ADDENDA TO CONTRACT DOCUMENTS VOLUME NO. 3

CONTRACT 876-HP

GEOMEMBRANE CAPPING AND
GAS COLLECTION SYSTEM
PELHAM BAY LANDFILL REMEDIATION
HUNTS POINT DRAINAGE AREA

ADDENDA TO CONTRACT DOCUMENTS - VOLUME NO. 3 - MAY 1994

REVISED DETAIL 2
CONTRACT DRAWING GS.3
PELHAM BAY LANDFILL, BRONX, NEW YORK

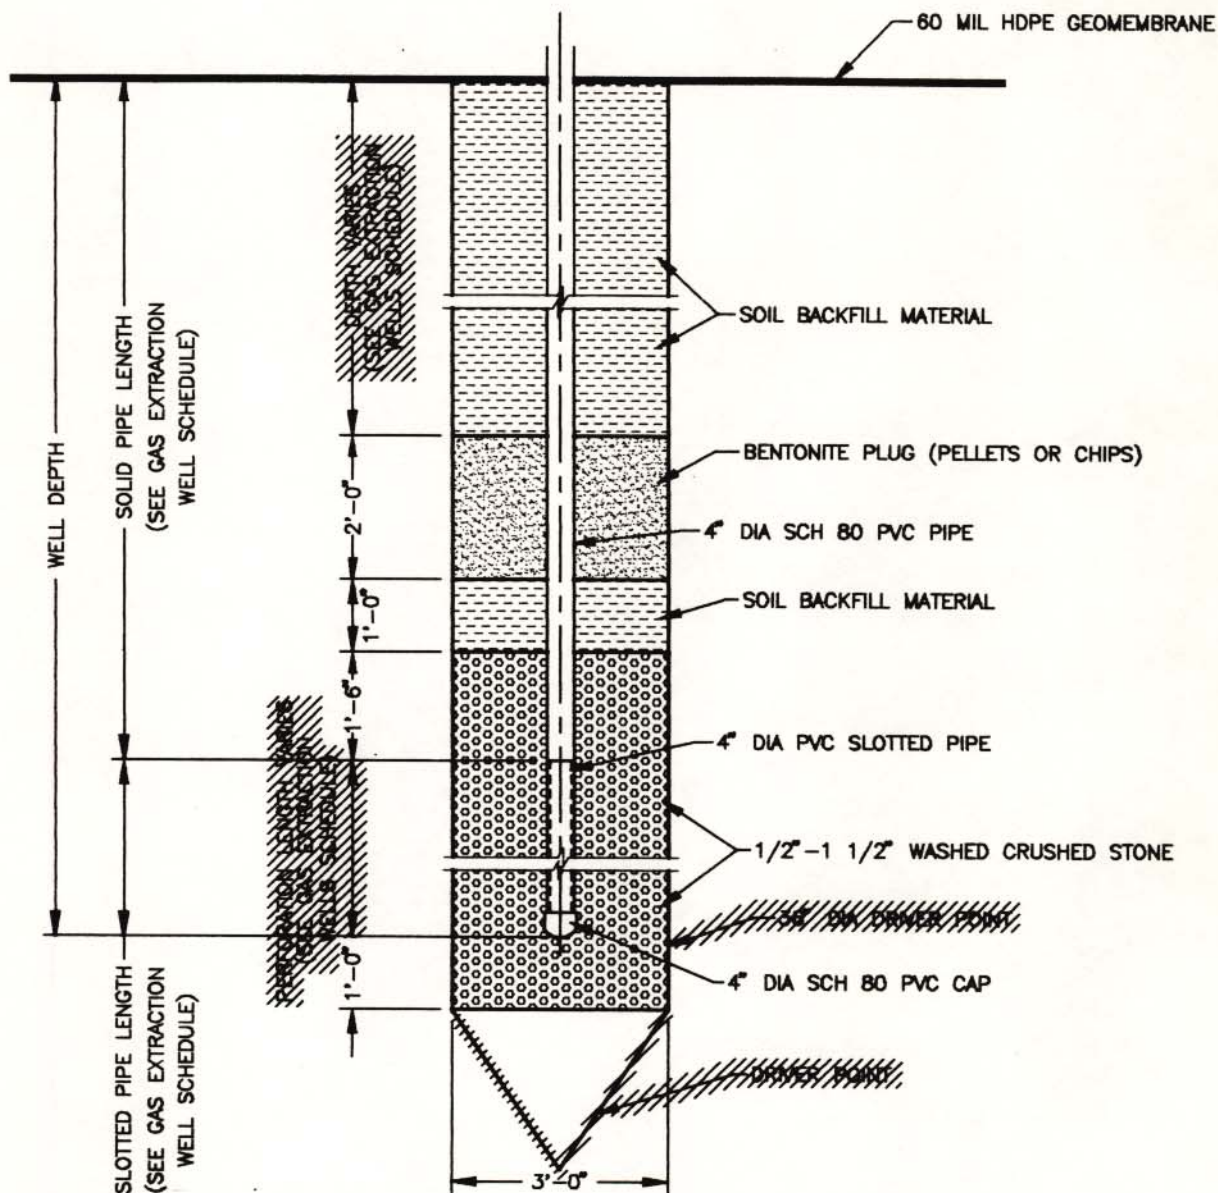
1. Replace Detail 2 and Detail 4 with the revised versions, attached on the following pages.

Reference Item #9 Gas Extraction Wells. On drawing sheet GS.3 Detail 2 (gas extraction well detail) indicates to work this detail with drawing GS.1 which has on it the Gas Extraction Well Schedule.

- A. The well depth is measured from the 60-mil HDPE geomembrane liner.
- B. Backfilling is independent of the depth of the extraction well. See drawing entitled "Revised Detail 2, Contract Drawing GS.3", on page 66 of this package. The revised detail addresses modifications below the 60-mil HDPE geomembrane liner only.

REVISED DETAIL 4			
CONTRACT DRAWING GS.3			
PELHAM BAY LANDFILL, BRONX, NEW YORK			
WOODWARD-CLYDE CONSULTANTS, INC.			
ENGINEERING & SCIENCES APPLIED TO THE EARTH & ITS ENVIRONMENT NEW YORK, NEW YORK			
DR.BY	WAB	SCALE 1/2" = 1'-0"	PROJ. 9204087
CK'D BY	MTZ	DATE MAY 25, 1994	PAGE NO. 87

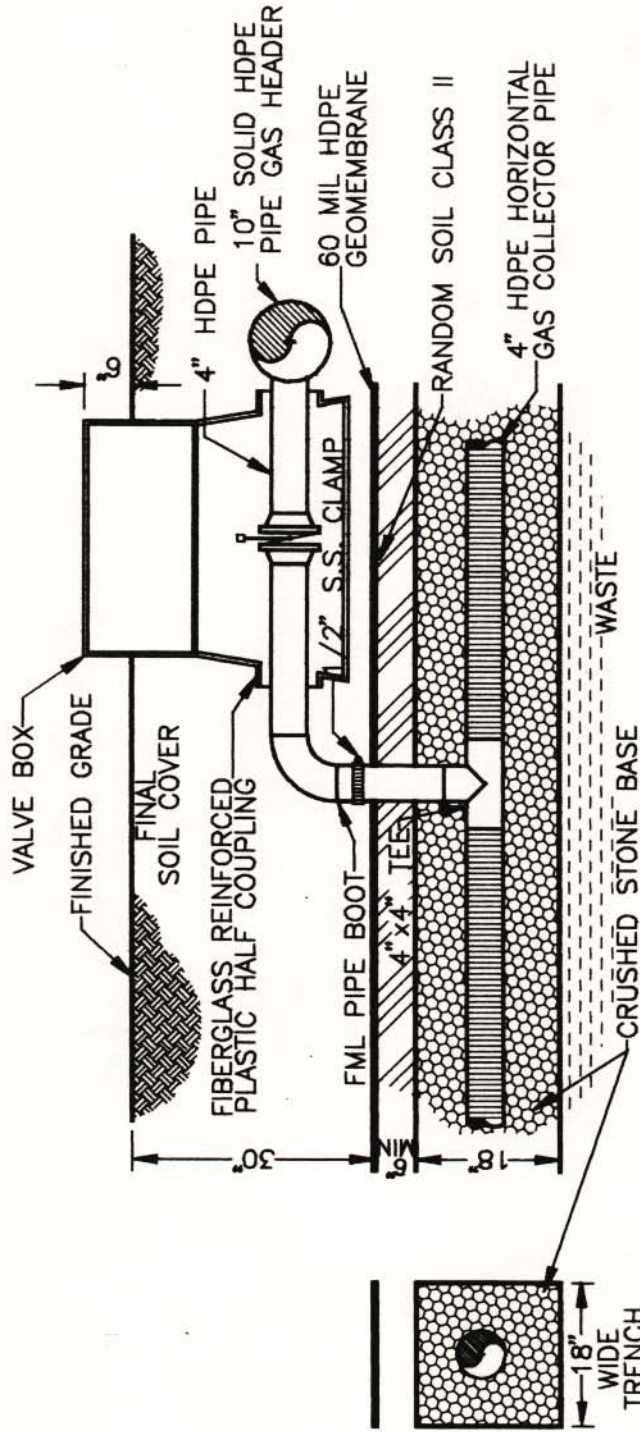
Refer to sheets 21 and 23/28. Horizontal perimeter gas collection pipe, Section 02715 and Bid Form p. 4, Item 31: Item 31 indicates the horizontal perimeter gas collection pipe is 4" HDPE. The pipe is shown on sheet 21/28 as being a 4" HDPE CORRUGATED GAS COLLECTION PIPE. On detail 4 of sheet 23/28 this pipe is shown as a 6" HDPE pipe. Which size is correct? Also, there is nothing to indicate if this pipe is solid or perforated. Further, are the joints on the horizontal perimeter gas collection pipe to be fusion welded, coupling (as shown on detail 4) or slip-on?

The horizontal perimeter gas collection pipe shall be 4-inch diameter, HDPE perforated and corrugated pipe. Joints on the horizontal perimeter gas collection pipe shall be fusion welded. See drawing entitled "Revised Detail 4, Contract Drawing GS.3", attached on page 67 of this package to reflect changes to the diameter of the pipe as well as the connecting tee.

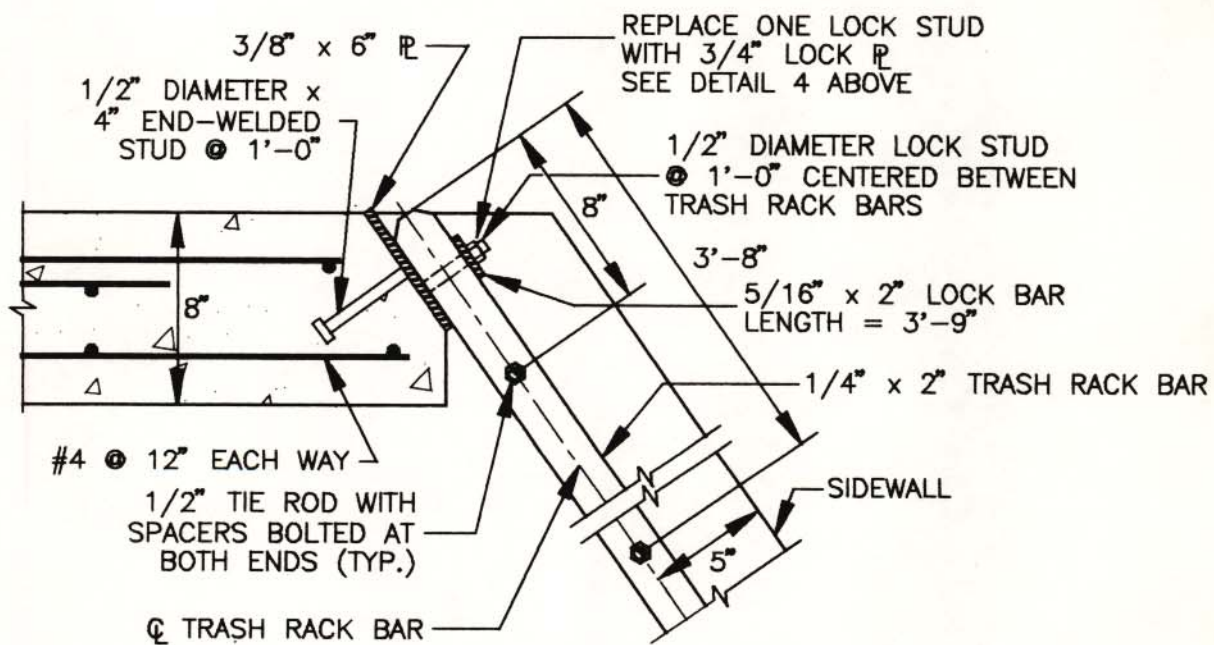
1. Replace Detail 2 with the revised version, attached on the following page.
